MECKLENBURG COUNTY
DEPARTMENT OF ENVIRONMENTAL HEALTH

PROPOSED PLOT PLAN

SOIL/SITE EVALUATION
for ON-SITE WASTEWATER SYSTEM

Re: 11119 Chestnut Hill Drive
File: 19565
Parcel: 231-123-22

Show profile locations and other site features (dimensions, reference or benchmark, and North).

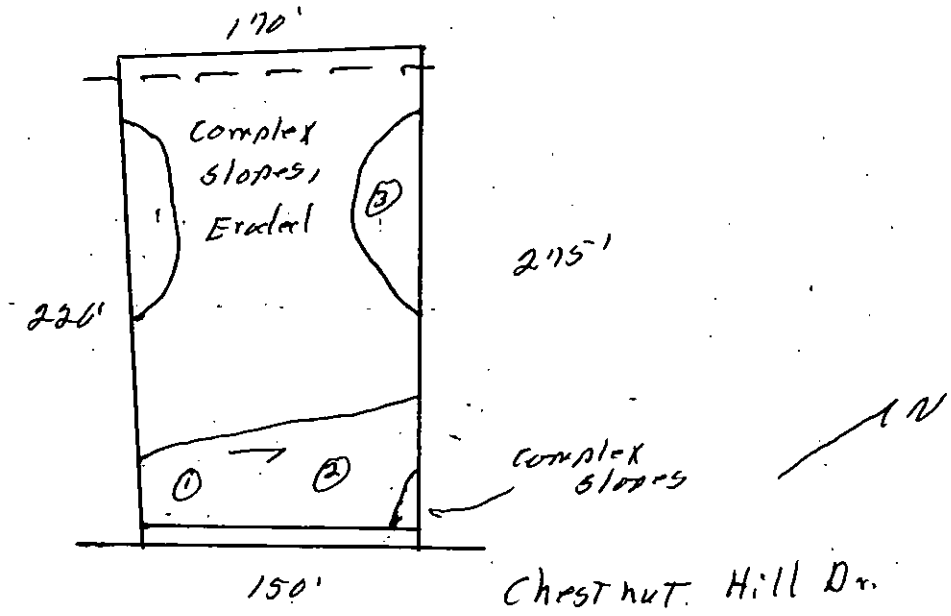
MMENTS: Soils in unexcaded areas have RPRBPS system depth- Area of these soils is very limited, it does not appear To Be 100% Acres

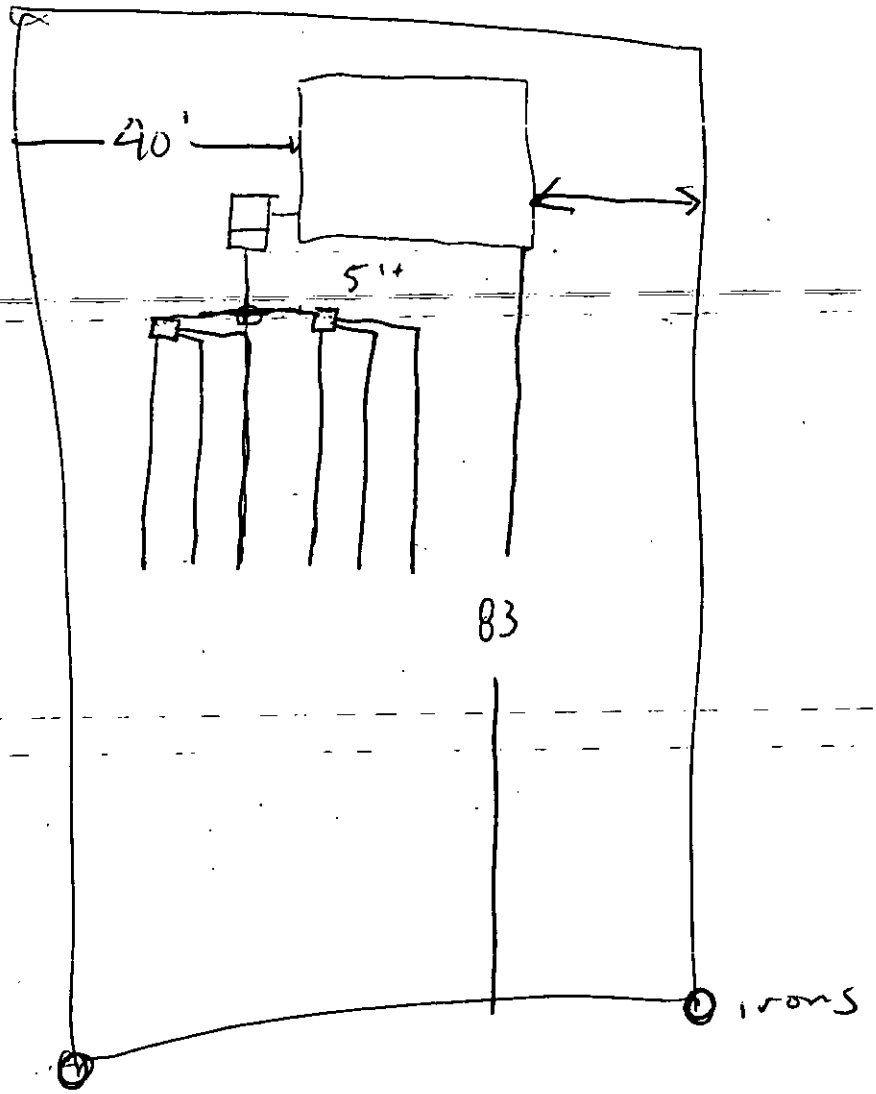
house now 73 from irons

need to set 83' from iron

where is driveway

where is well
